Public Comments and Responses

PUBLIC COMMENTS AND RESPONSES
TMDLs FOR NITRATE AND PHOSPHORUS IN ROLLING FORK
January 10, 2006

**Tyson Discharge
Attachment A**

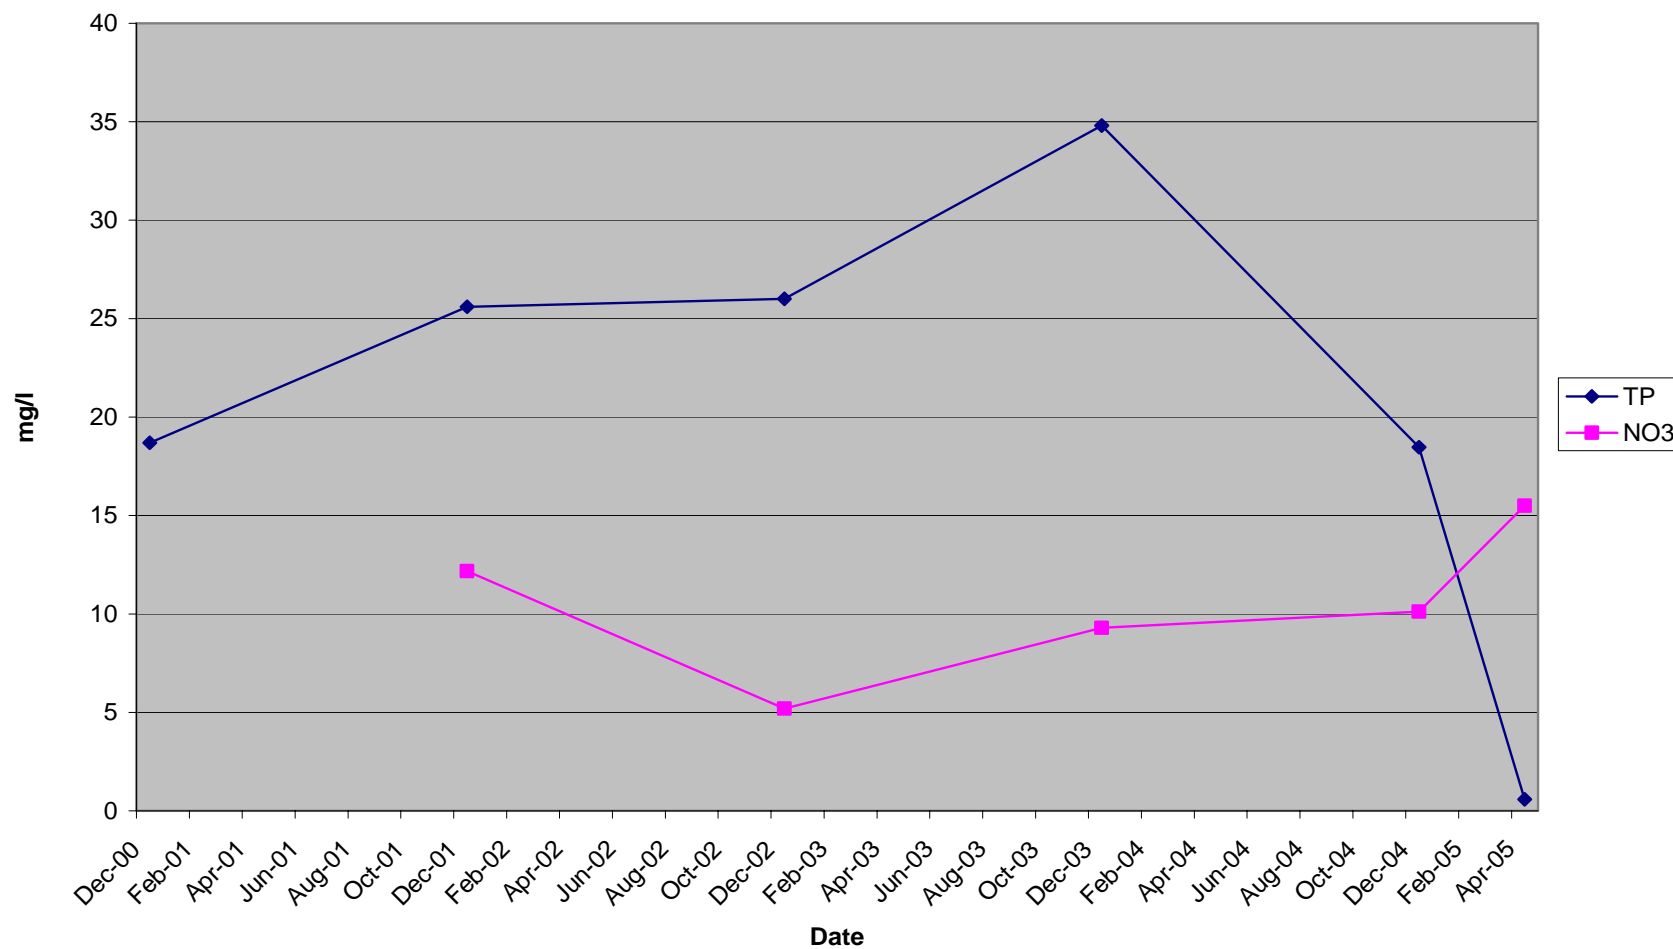
Tyson has also made modifications at its Grannis processing facility that should be considered when considering the development of a Nitrate TMDL. Tyson modified the design of the wastewater began in 2001 that led to reduced discharge of Nitrate Nitrogen levels. The effluent from the wastewater treatment system has consistently been below 20 mg/l during this four year period. Based on data obtained from ADEQ monitoring station RED58, the in-stream concentrations for Nitrate Nitrogen has consistently reduced during the past four years. However, the in-stream monitoring data shows a cyclical increase in Nitrate Nitrogen between August and October each year. Since the in-stream monitoring results are not consistent with the discharge levels associated with the Tyson location, it would appear the elevated Nitrate Nitrogen levels could possibly be a natural cycle that occurs within the stream. Other than the data obtained during the fall, the in-stream concentration level is fairly consistent. Tyson has included a graph of the Grannis effluent concentrations (Attachment A) and a graph of the Grannis effluent in conjunction with the in stream data (Attachment B). The graphs indicate the increased Nitrate levels in the stream are not the result of a discharge from the Tyson facility or any other industrial facility. Additional stream monitoring is needed. Therefore, Tyson requests that the Designated Category be changed from a 5A to a 5D.

Response: EPA commends Tyson for reducing nitrate levels discharged from its Grannis facility. As mentioned above, a TMDL for nitrate was still required because the nitrate impairment for Rolling Fork has been on the 303(d) list since at least 1998 and it is included in the consent decree from the Arkansas TMDL lawsuit. As ADEQ noted in their Responsiveness Summary to Comments on the 2004 draft 303(d) list, the cyclical increases of nitrate between August and October each year are probably due to effects of Tyson's discharge during periods of decreased ambient streamflow to dilute the effluent.

State Data (RED58)
Attachment C

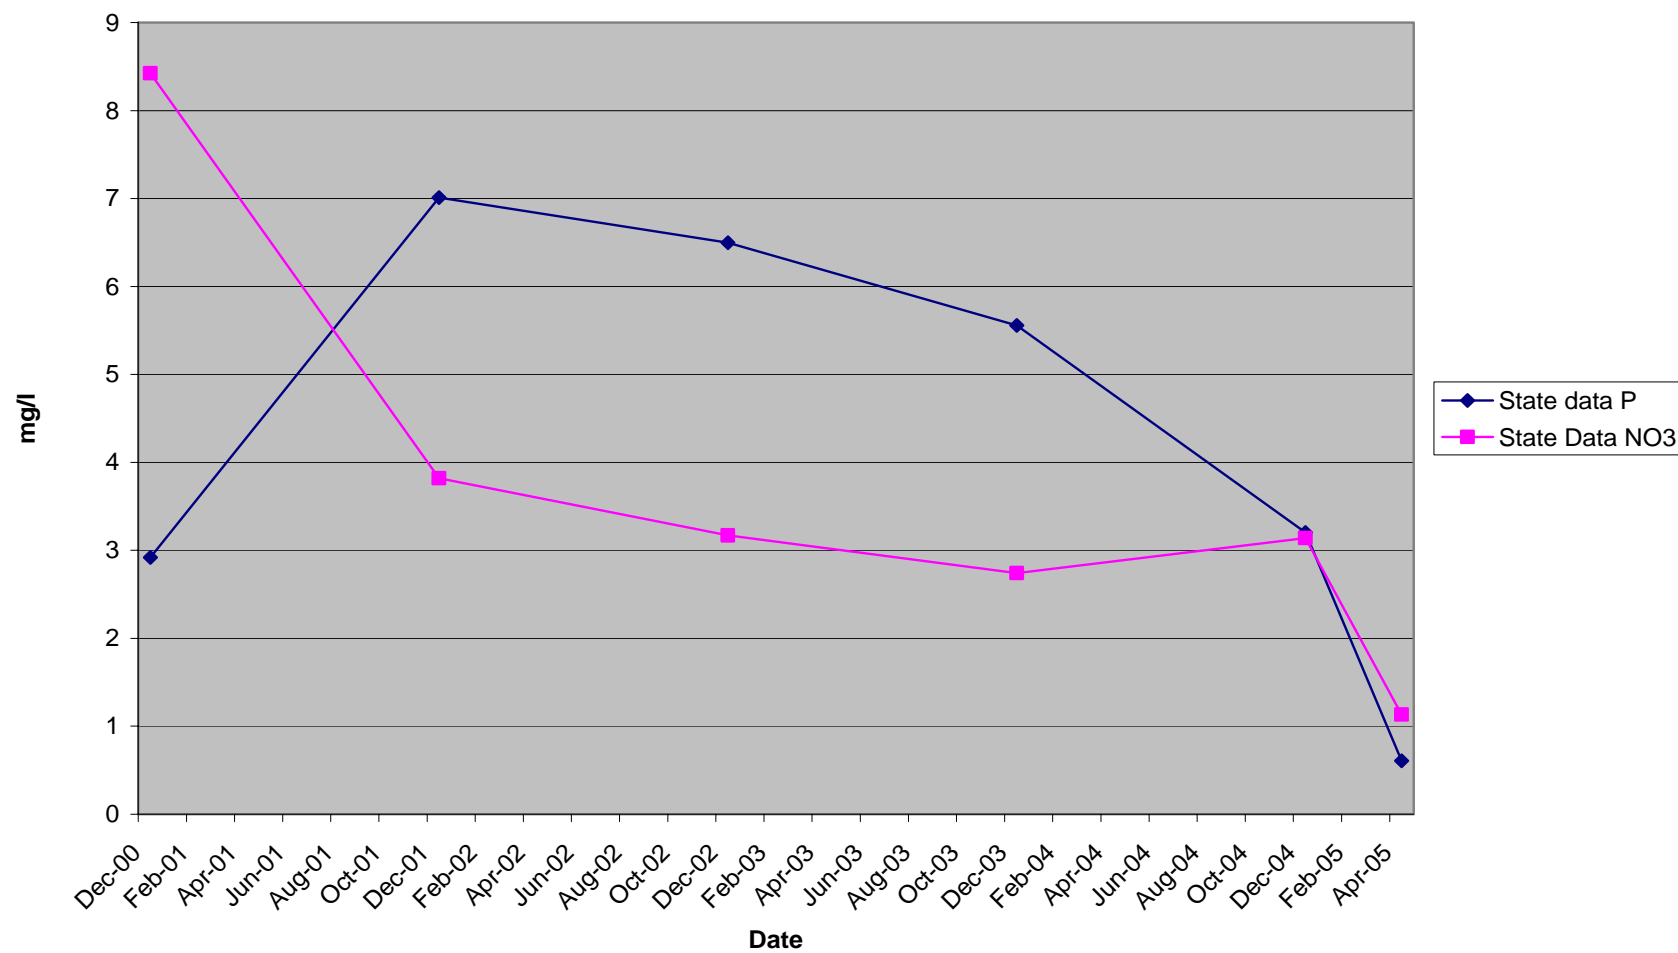
According to existing ambient monitoring data (2000-2005) at station ARK0058 and ARK0030 the nitrate TMDL is currently being met during average conditions downstream of the discharge. The TMDL report establishes a Nitrate TMDL of 6,025 lbs/day. The in stream nitrite plus nitrate levels on average do not exceed 4.6 mg/L. Therefore, the existing average load is no more than 2,770 lbs/day at average flow, well below the recommended TMDL. In addition the 80th percentile nitrite plus nitrate level at ARK0058 is only 8.3 mg/L and the 90th percentile is 11.9 mg/L (the 90th percentile nitrate level at ARK0030 is <2.0 mg/l), indicating that the recommended in stream target (which, as described previously, is an inappropriate target) is rarely exceeded. Therefore, a nitrate TMDL is unnecessary and the current effort should be used to de-list the segment for nitrate.

Response: The historical average nitrate concentrations in Table 3.1 of this report are consistent with the statistics mentioned above for station RED0058. A TMDL for nitrate was still required because the nitrate impairment for Rolling Fork has been on the 303(d) list since at least 1998 and it is included in the consent decree from the Arkansas TMDL lawsuit.
